Minute No. 423
Report – Standing Policy Committee on Infrastructure Renewal and Public Works – June 9, 2009

Item No. 4 Upgrading of Chochinov Park - Funding for Improvements (Old Kildonan Ward)
eFile PR-7(34)

CHOCHINOV PARK
Facilities Assessment

Three Phase Cost Estimate

Site Furniture

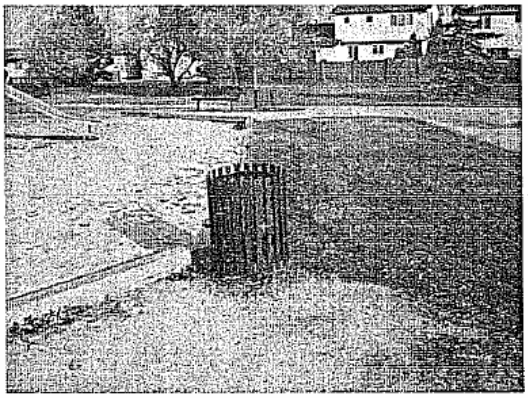
The three metal benches are rusting and one is badly misshapen and dented on the seat. The concrete foundations are heaved up from the asphalt.

The metal slat waste receptacle appears in good condition. There is an expanded metal waste receptacle chained to a tree. The picnic table is a moveable one and appears in good condition.

Recommendation: Remove and replace the three benches. Retain the waste receptacle if possible given the other demolition occurring around it. Retain the picnic table.

Fencing

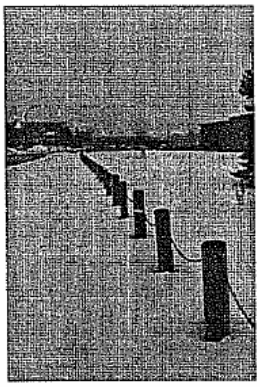
The bollard and chain fencing along Garden Park Drive is in good condition with the exception of one or two posts, which are split. The park service access point is at the south end of the bollard fencing. The chain link fencing along the NE end is in good condition.

Recommendation: No replacement is required.

Playground

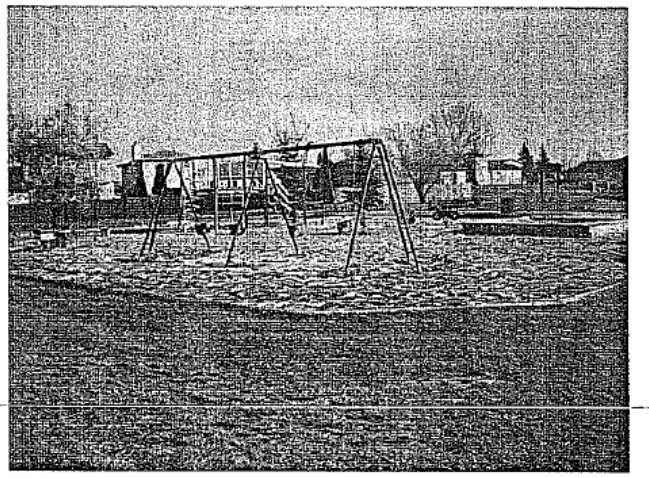
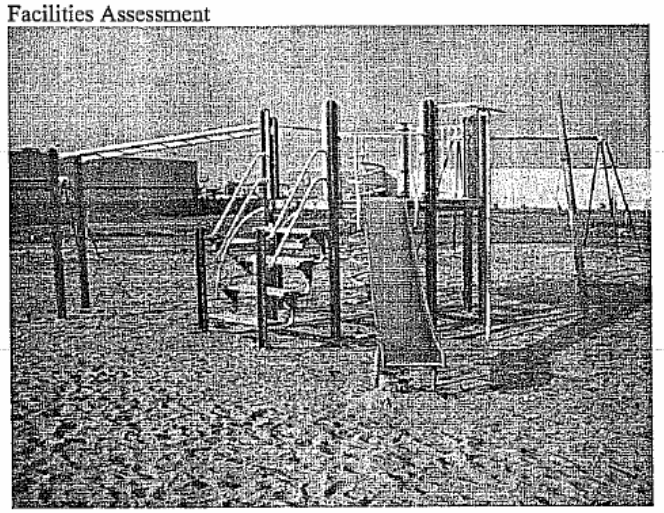
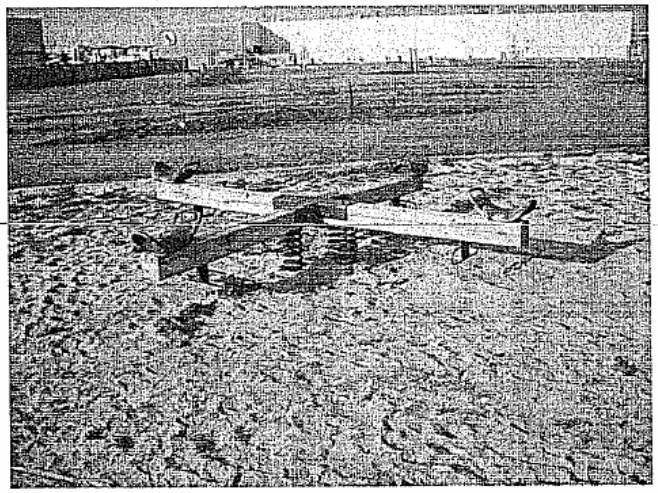
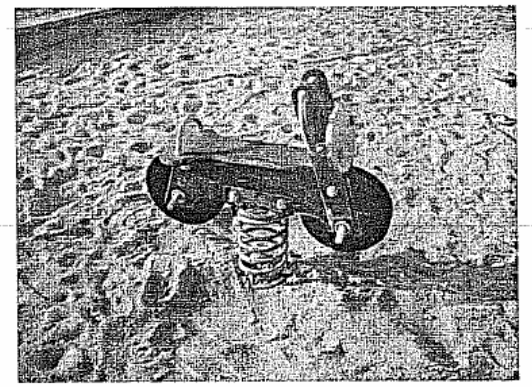
The timber edging and sand box are pressure treated timbers nearing the end of their life cycle and are in poor condition. The sand surfacing is inundated with weeds and is not an adequate safety surface for the playground, not meeting CSA standards for depth. The layout of the play equipment does not meet CSA standards with overlapping and inadequate safety zones.

The playstructure is a ± 20 year old metal Gametime structure. The spiral slide has been removed leaving a metal post standing alone and the access point has been boarded over. The stairs have open risers that are too high for small children, and do not meet CSA regarding protective barriers and kickplates. There are four climbing/sliding components with no handholds or protective barriers at the top, which does not meet CSA. The platform does not meet CSA for protective barriers. The steps and platform are wood and are weathered and with slivers. The structure is obsolete with respect to design and construction, making it impossible to obtain parts necessary to retrofit it. It has very limited play value and is not accessible or safe for young children (2-5yrs).

The buck-about is wood and metal, with loose connectors creating pinch points. The paint is worn. The wood has slivers.

The spring toys have been repainted at some time but are worn. The springs are rusting. There are parts missing from at least one.

The swings have old flaking paint that could be lead based. They do not have adequate safety zones in conjunction with other play equipment.

Generally all the equipment is worn and unsightly.

Recommendation: Remove and replace all play equipment, edging and safety surfacing.

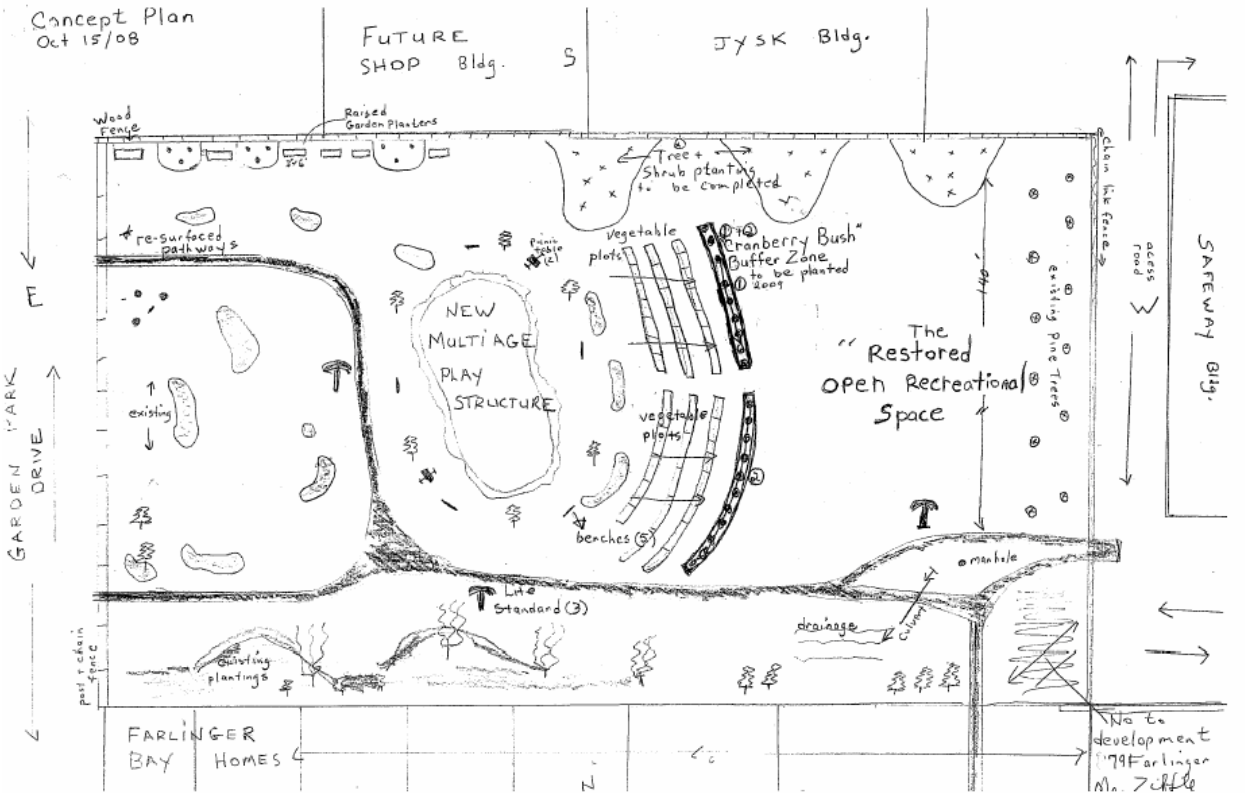
1) The open recreational space has been restored by re-locating some trees and shrubs and doing the necessary re-sodding. This grassed area can now be used for children's recreational activities. The new tree plantings will greatly enhance the area with a green border in years to come made up of the pines, spruces and cranberry bushes.

2) The new play structure features can be multi-faceted with a landscape component inside and out. The additional trees provide shade to area as well.

3) There are new benches to be added which can face in towards the play structure and others out toward the garden.

4) Addition of low level intensity lightning, I was informed that a solar type is available.

5) Re-surfaced pathways to replace the broken down and uneven ones presently. At some points, only two feet in width.
